Transmission Symptom - Scraping Noises when Changing from 1st to 2nd Gear (SY 167/21)

Vehicle Type: **718 Spyder (982)/718 Cayman GT4 (982)**

Equipment: **6-speed manual transmission (M-no. 480)**

Installation position of balancing weight

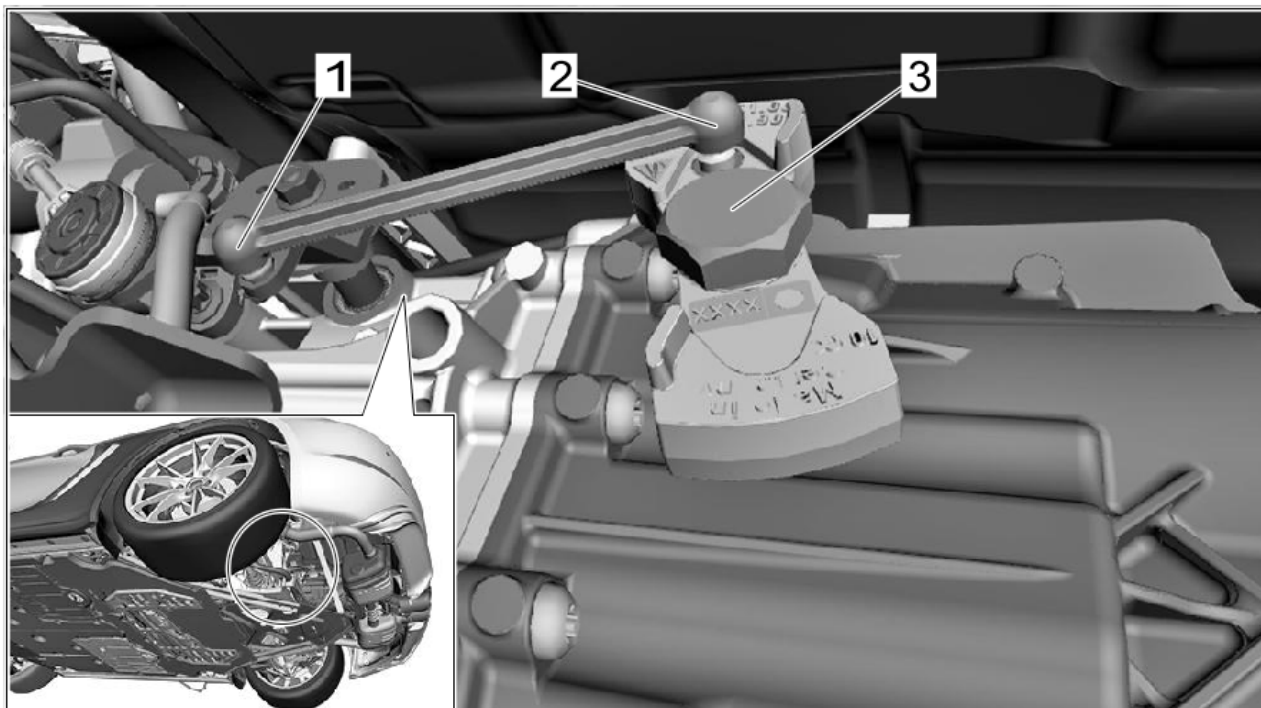
Remedial Action: In the event of a complaint, a balancing weight can be retrofitted on the manual transmission.

Please note that retrofitting the balancing weight changes the vehicle's shift feel. As a result, shifting can then be perceived as less sporty than before and is then comparable with the shift feel of the 718 Boxster/Cayman GTS 4.0 (982).

Work Procedure: 1 Position balancing weight on the transmission and tighten with fastening screw ⇒ *Installation position of balancing weight -3-*.

Tightening torque 30 Nm +5 Nm

- 2 Press reversing lever onto ball joints ⇒ *Installation position of balancing weight -1-* and ⇒ *Installation position of balancing weight -2-*.

After installing the reversing lever, check that it is installed securely and correctly.
